J.L. SCHWARTZ WWTP

4.0 MGD ADDITION

RECORD DRAWINGS 11-91

P&ID
PROCESS AND INSTRUMENT DRAWING

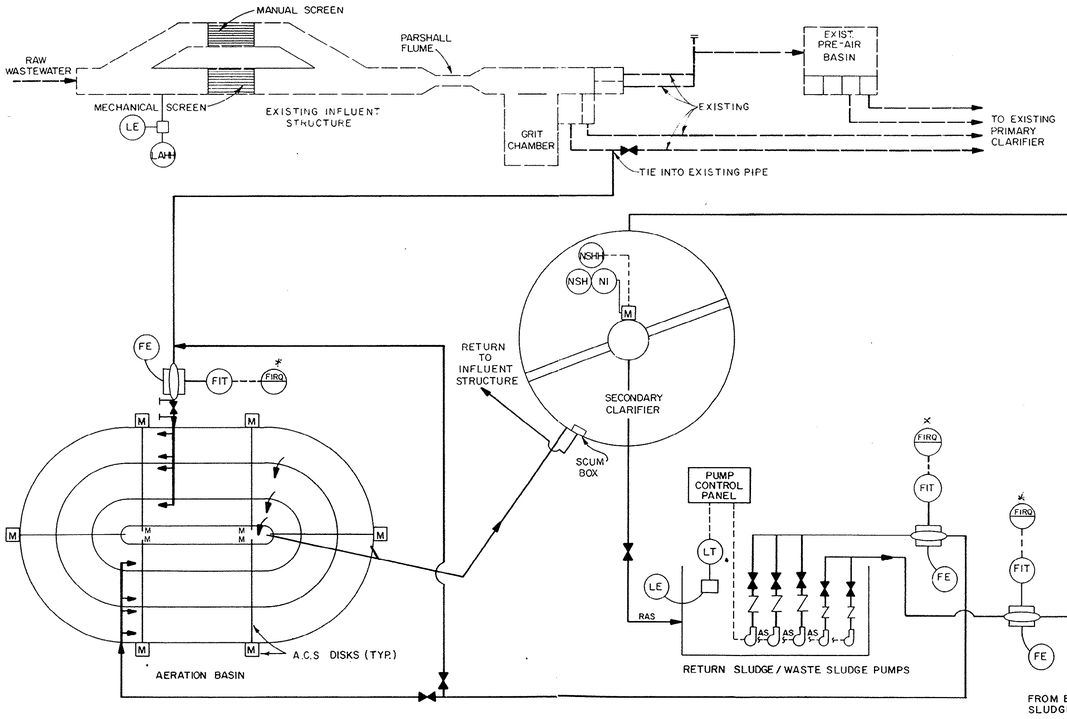
* CHANGE ORDER NO. 1, ITEM "A" DELETED THE THREE (3) STRIP CHART RECORDERS ON THE STRAP-ON ULTRASONIC FLOW METERS.

LADDER DETAIL 1-10-10

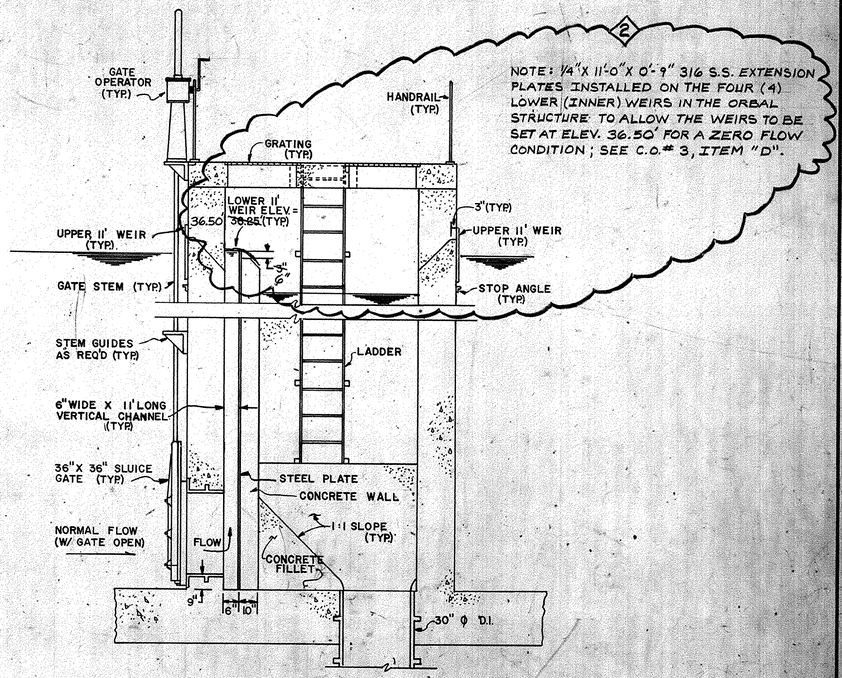
NOTE: 1/4" X 11'-0" X 0'-9" 316 S.S. EXTENSION PLATES INSTALLED ON THE FOUR (4) LOWER (INNER) WEIRS IN THE ORBAL STRUCTURE TO ALLOW THE WEIRS TO BE SET AT ELEV. 36.50' FOR A ZERO FLOW CONDITION; SEE C.O.# 3, ITEM "D".

PLAN VIEW

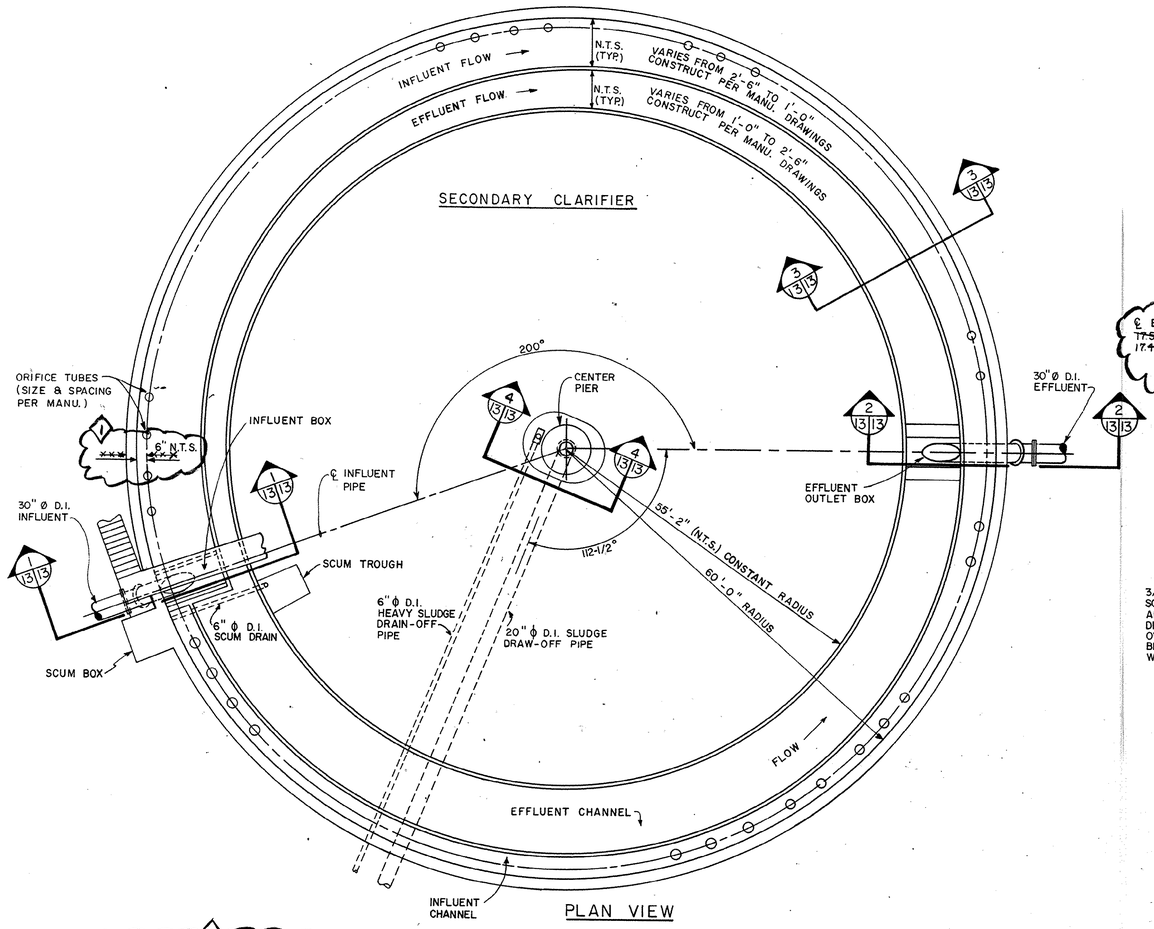
NOTE: SEE STRUCTURAL PLAN SHEET S9, SECTION 2 FOR THICKENED CONCRETE BASE SLAB AT THE CLARIFIER CENTER PIER; 6'-6" RADIUS X 4'-6" DEPTH.

WET WELL & MCC PLAN VIEW

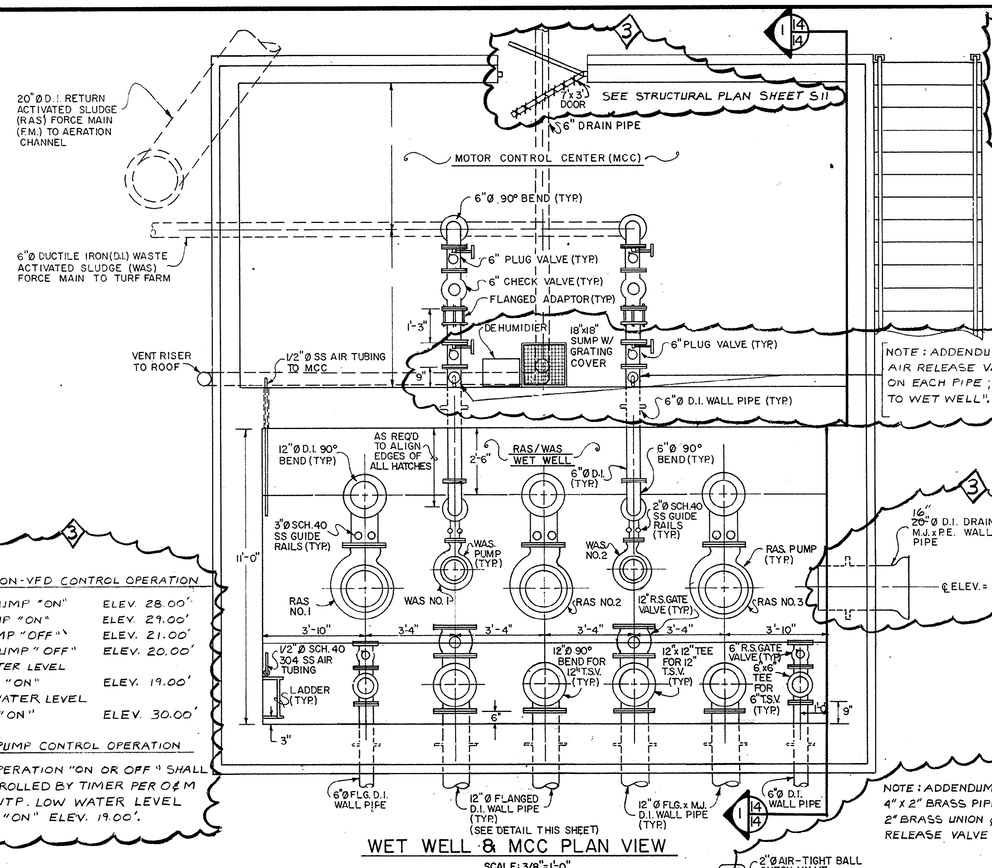
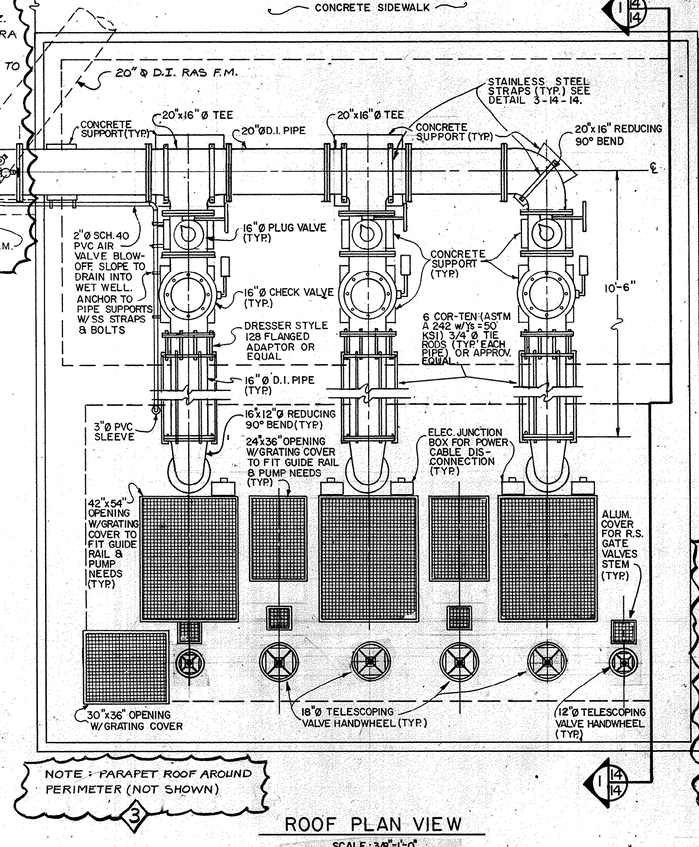
NOTE: THE TOP 20"Ø D.I. 90° BEND INSTALLED ROTATED 90° TO A HORIZ. PLANE POINTING NORTH, ONE (1) EXTRA 20"Ø D.I. 90° BEND INSTALLED FOR THE VERTICAL DROP. THIS WAS DUE TO INTERFERENCE BY THE NEW U.G. ELECTRICAL CONDUIT, SEE ELEC./ DRAWING E-3, POWER PLAN.

THREE ~~TWO~~ - 20"Ø D.I. 90° BENDS: UPPER = FLG. x FLG. TWO ONE LOWER = M.J. x M.J.

SECTION 2 - 15 - 16

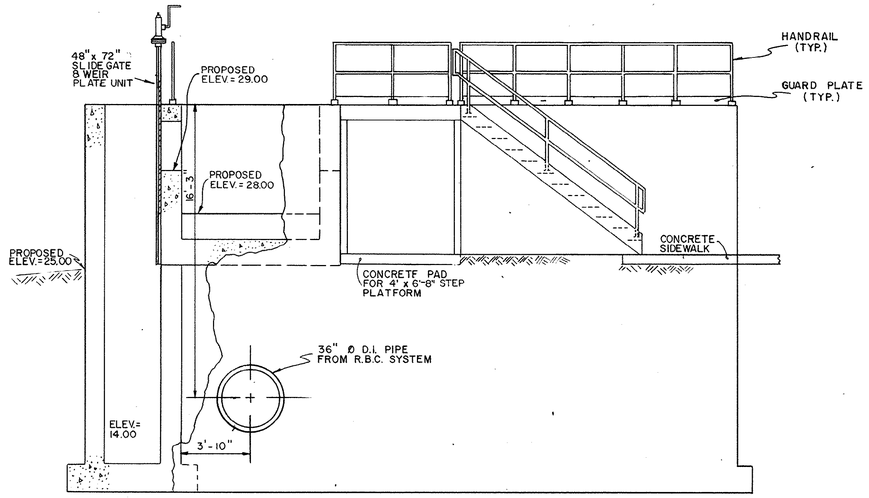
NOTE: THE 16" ⌀ PLUG VALVE HANDWHEEL STEMS INSTALLED VERTICALLY IN LIEU OF AS SHOWN.

SECTION

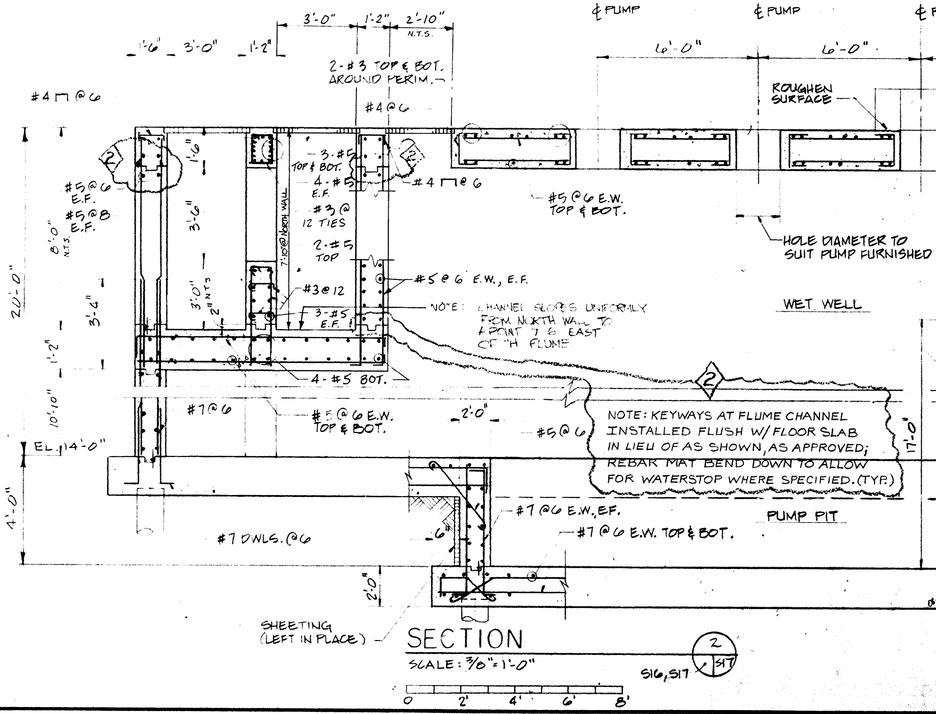
NOTE: TWO (2) PILES AT THE VALVE VAULTS SOUTH WALL INADVERTENTLY DRIVEN 12" SOUTH OF SHOWN LOCATION; BASE SLAB AND REBAR MATS LENGTHENED 12" DUE TO THIS, AS APPROVED. SEE ABOVE CHANGES.

SECTION 1 E9 E9

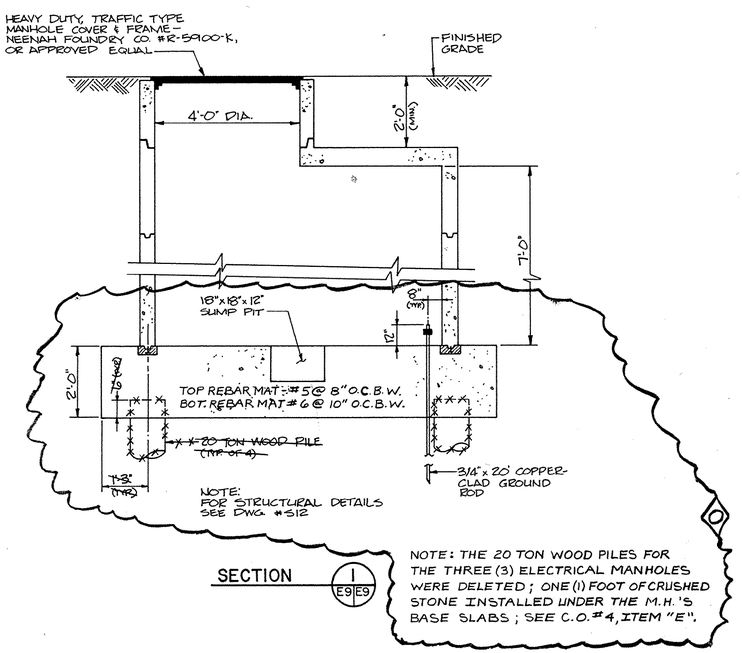
NOTE: THE 20 TON WOOD PILES FOR THE THREE (3) ELECTRICAL MANHOLES WERE DELETED; ONE (1) FOOT OF CRUSHED STONE INSTALLED UNDER THE M.H.'S BASE SLABS; SEE C.O. #4, ITEM "E".
